# Addendum #4

Project Name:	North Greeley Sewer
Bid Number:	F24-11-096
Date:	December 9, 2024
Project Manager:	John Goin, P.E.

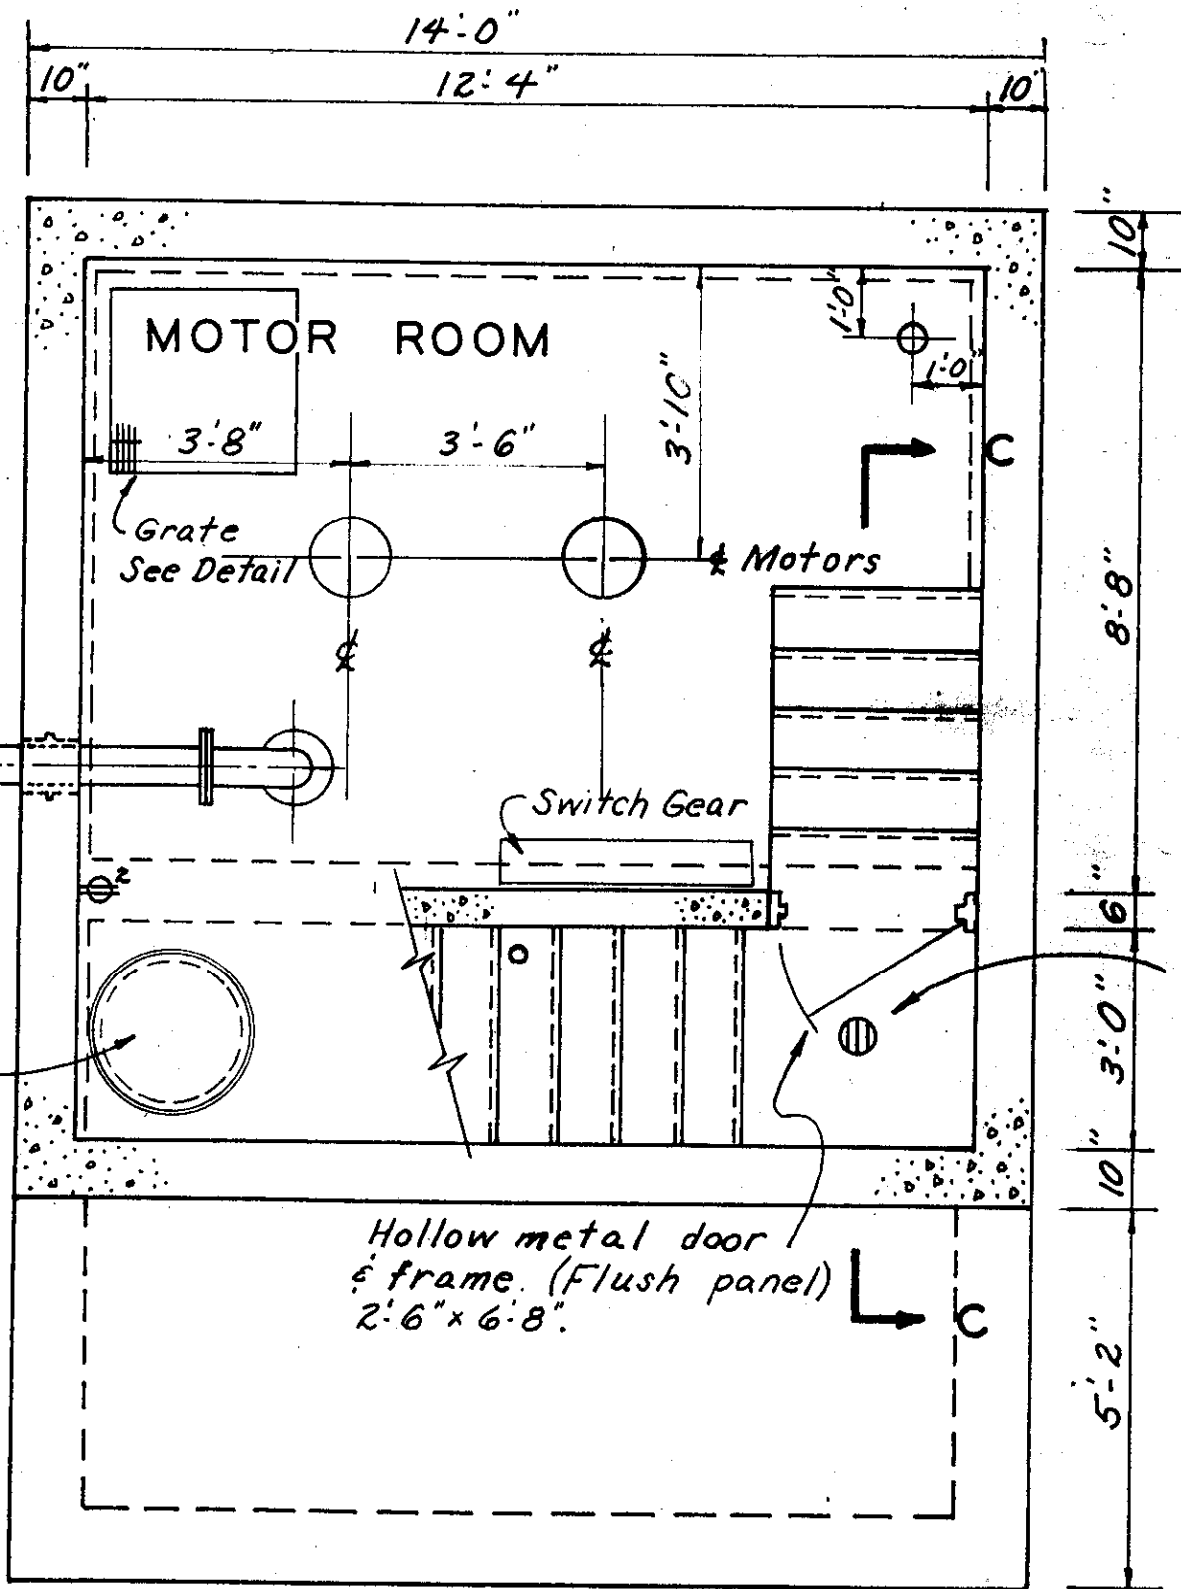
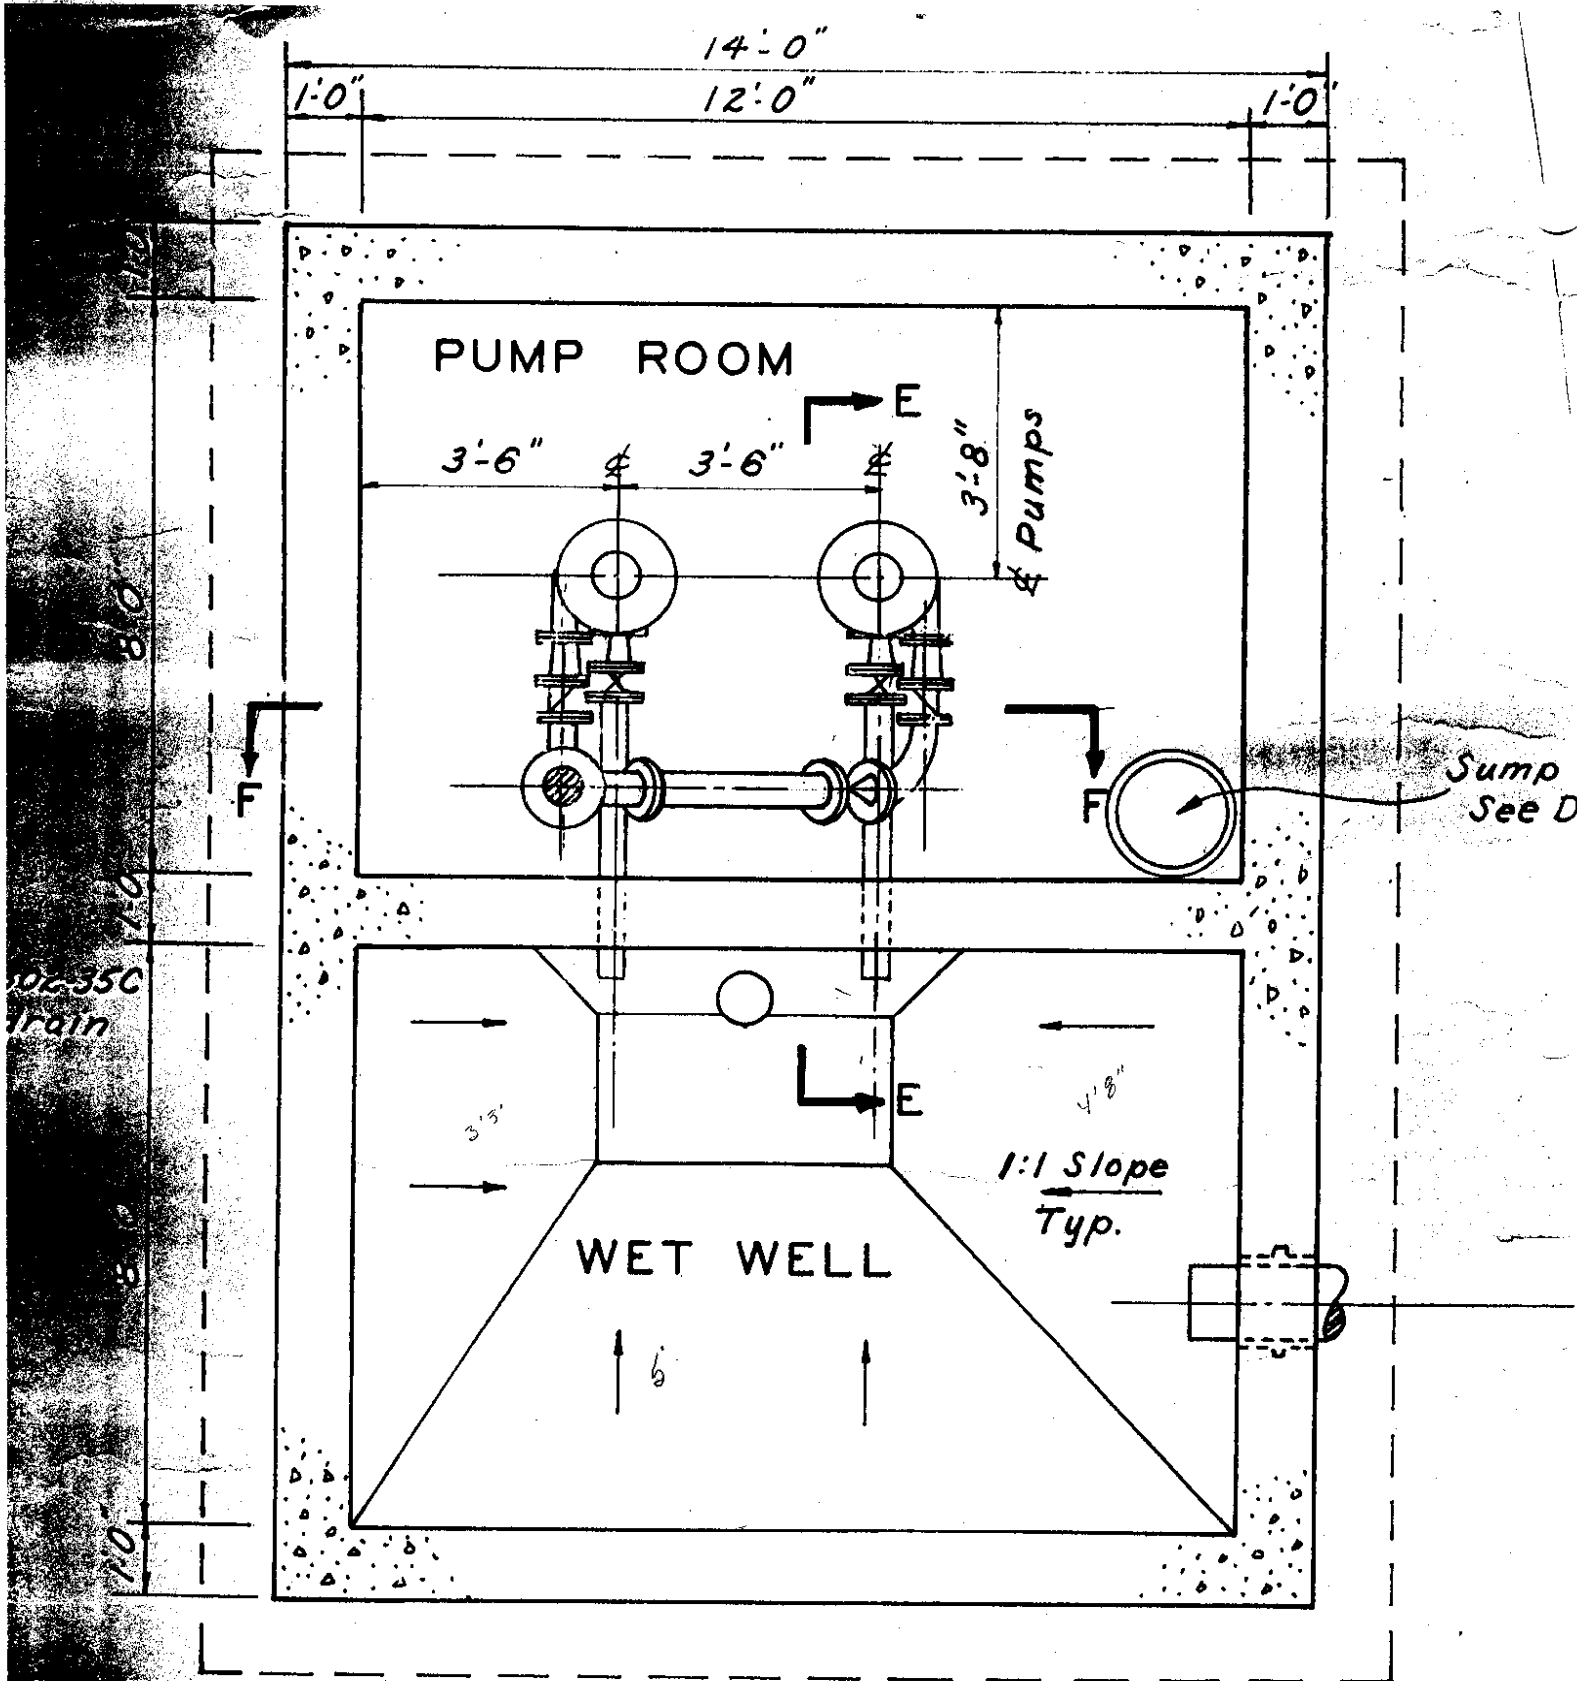
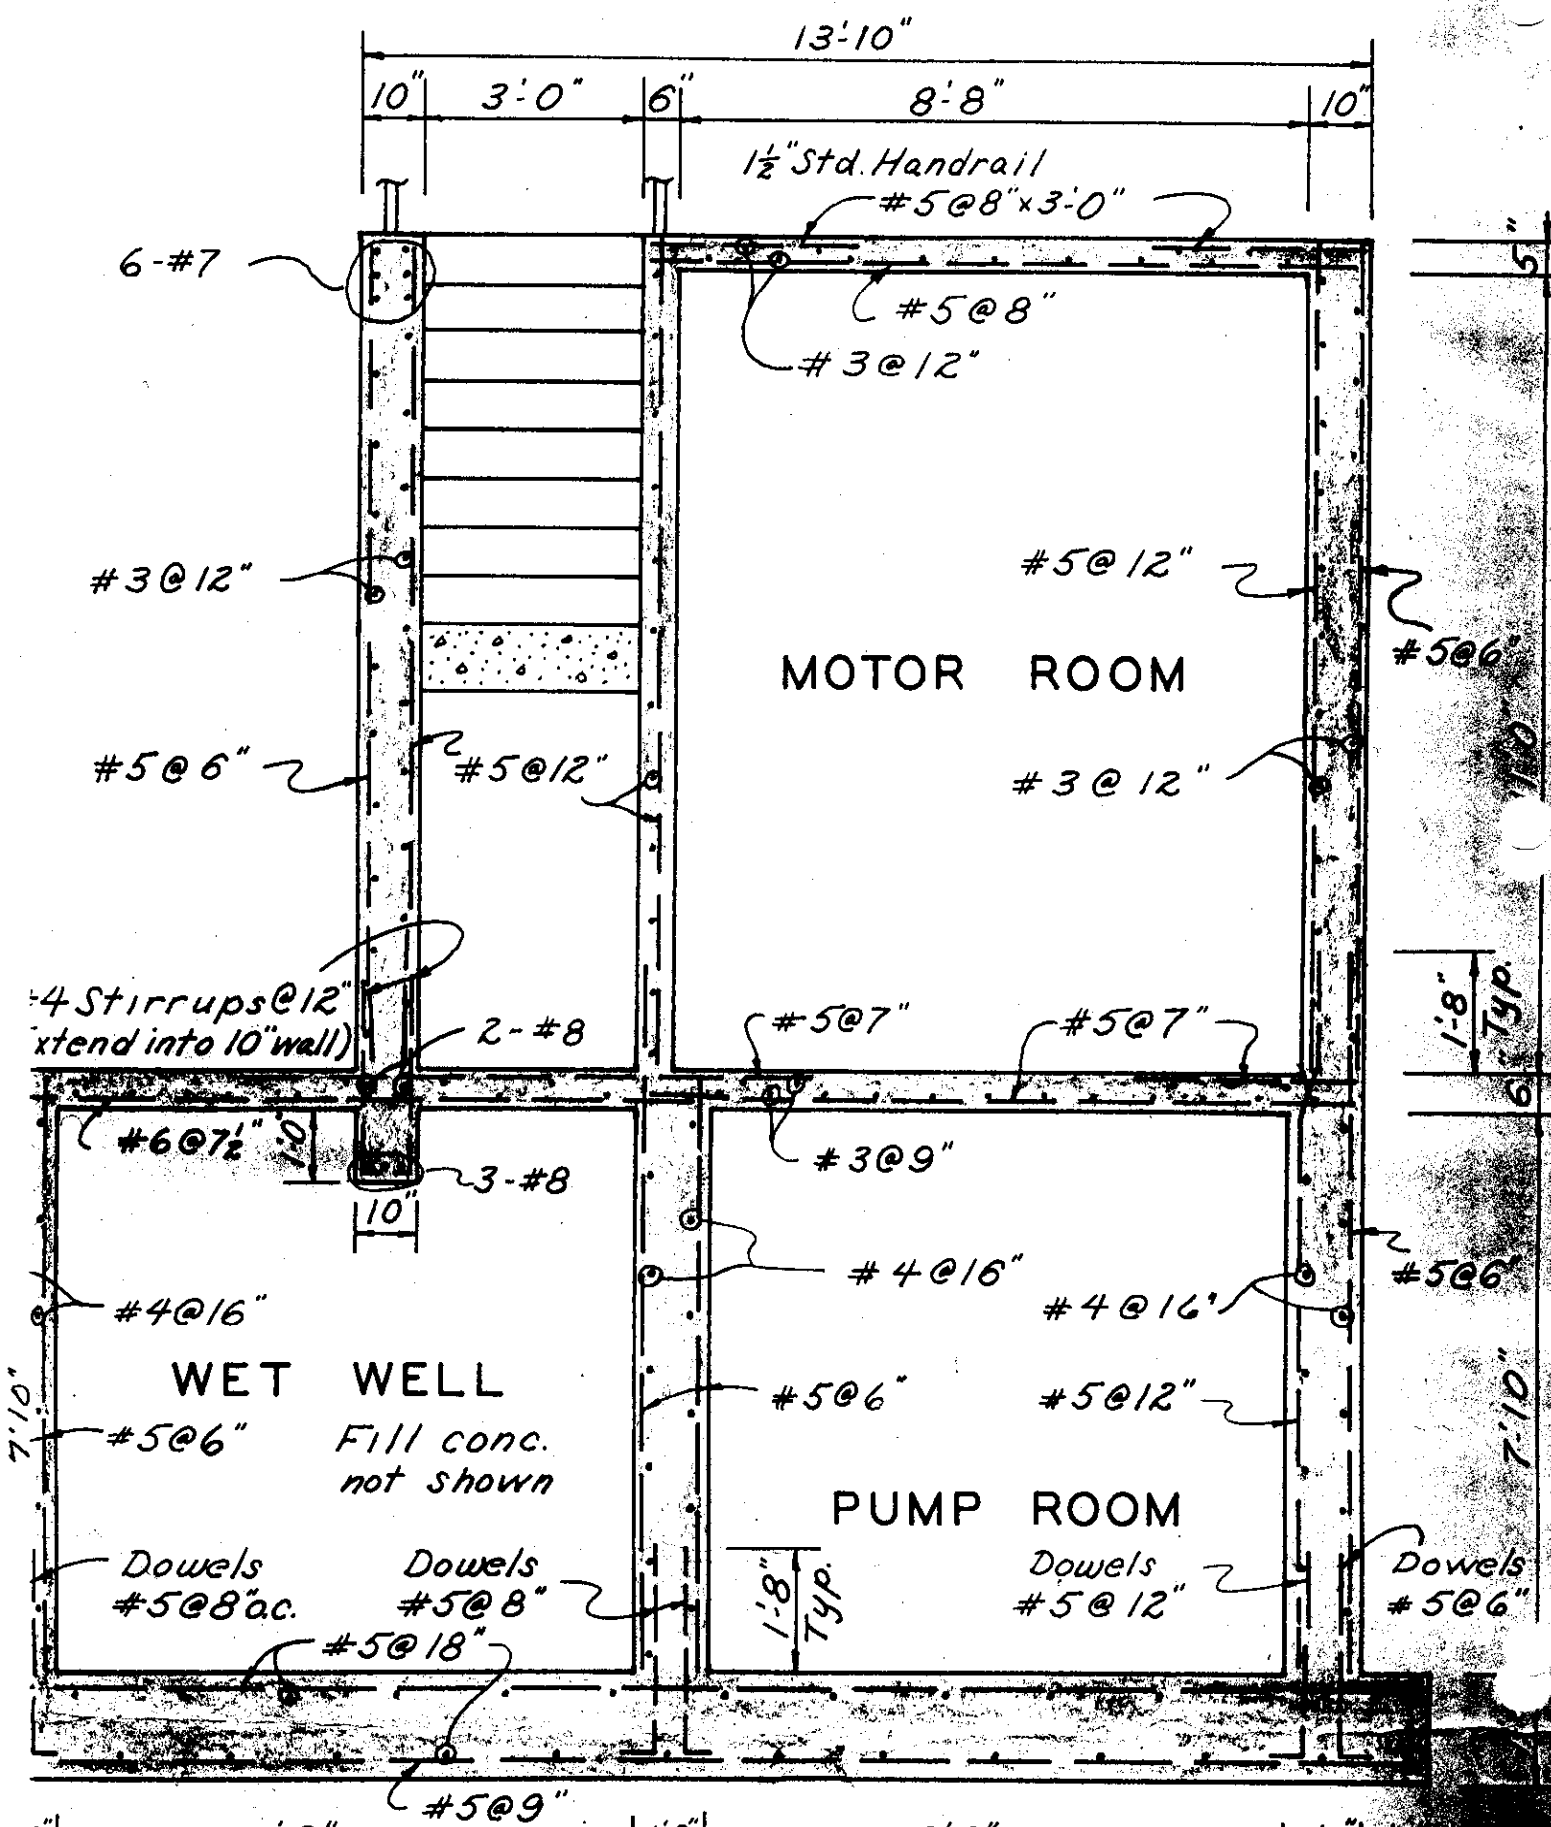
Question #1	Can the as-builts for the existing Segment 2 lift station, that is to be removed, be provided?
Answer	<a href="#">Lift Station #1 as-built information is provided with this addenda.</a>
